Enclosed is the revised draft biannual report for the project "Evaluation and Compilation of DOE Waste Package Test Data," NUREG/CR-4735, Volume 7 (FIN-A4171), as you requested. If you have any questions, please call me.

NUREG/CR-4735
Volume 7

**EVALUATION AND COMPILATION OF DOE
WASTE PACKAGE TEST DATA**

BIANNUAL REPORT

Ratio of leach
rates; $\frac{\text{DWRG}}{\text{TDS-131}}$

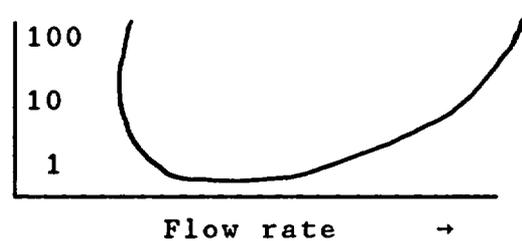
However, the picture is complicated by the fact that those glasses that reach a high equilibrium pH at low flow continue

to decompose quite readily at these low flow rates. A comparison of a relatively resistant glass, DWRG, with a less resistant glass, TDS-131, would indicate the following relative solubility with flow rate.

This highlights a "worst case scenario," where conditions alternate between slow flow and fast flow.
